service bulletin

No. 98-1

Power Trim Piston/Rod Replacement P/N 43397A6

1998 150 - 225 HP Pro Max/Super Magnum 2.5L &
1998 300 Pro Max/Super Magnum 3.0L

Date code explanation:

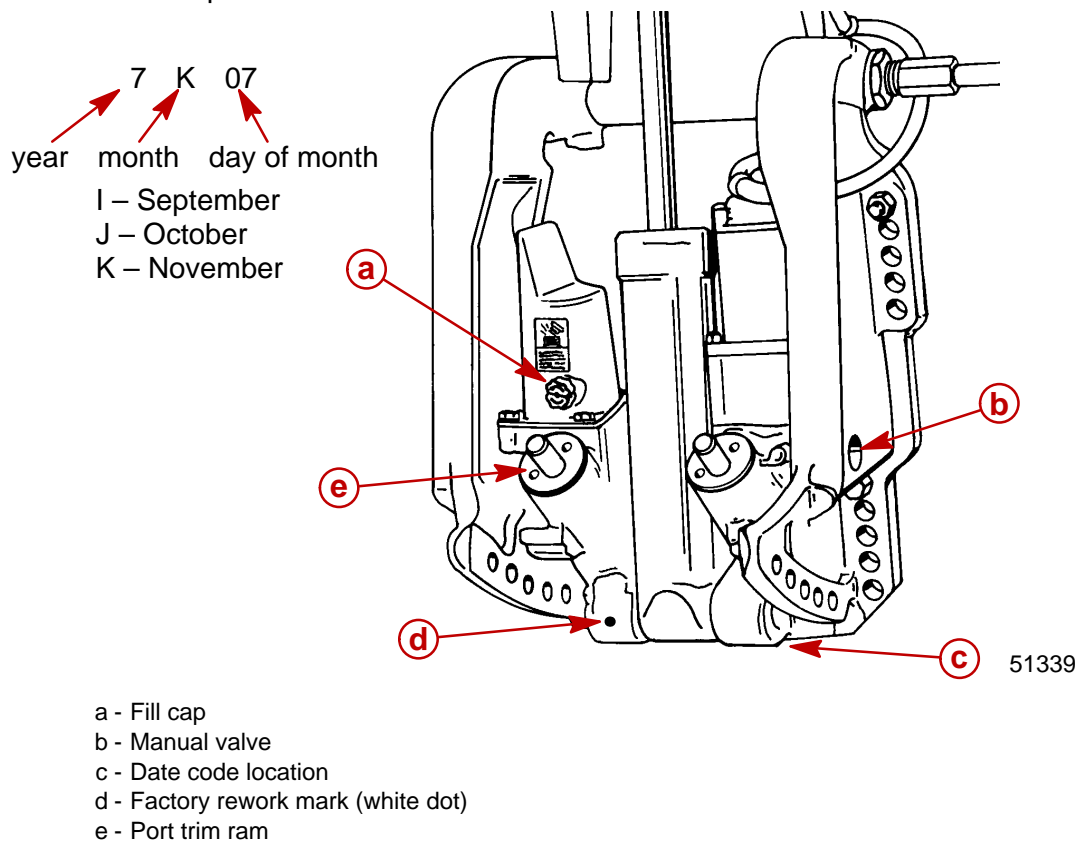
Any engine that **DOES NOT** have the factory rework marking, should have the anode assembly removed from the power trim, to inspect for affected date codes. Affected date codes are 7I02 thru 7K07. Power trims with date codes that are not in the affected range do not require trim piston/rod replacement.

- a - Trim rod removal tool (91-44486A1)
- b - Spanner Wrench (91-74951)
- c - Cap removal tool (91-44487A1)

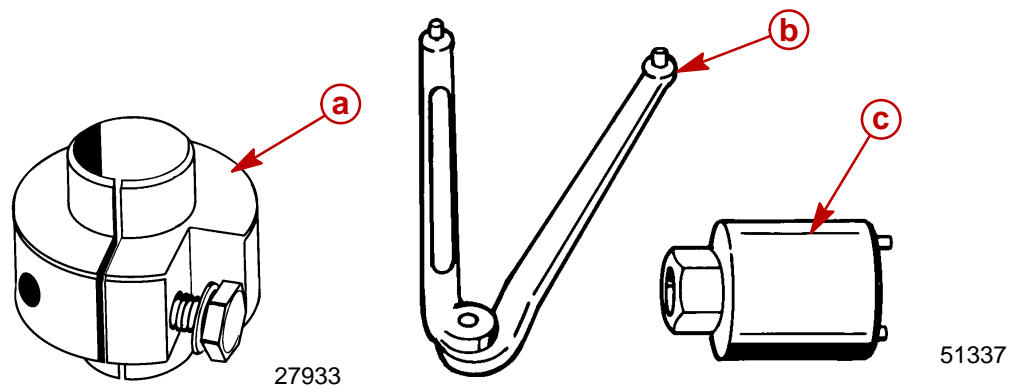
Loosen the port side trim rod cylinder cap using spanner wrench (91-74951), or cap removal tool (91-44487A1) . Before removing , clean any dirt or loose paint chips from around cap area.

Install trim rod removal tool (91-44486A1) and pull trim piston/rod assembly from cylinder.

Install cylinder cap over new piston/rod assembly.

Apply Quicksilver Power Trim and Steering Fluid on all O-rings and seals before installation.

Install trim rod and cap.
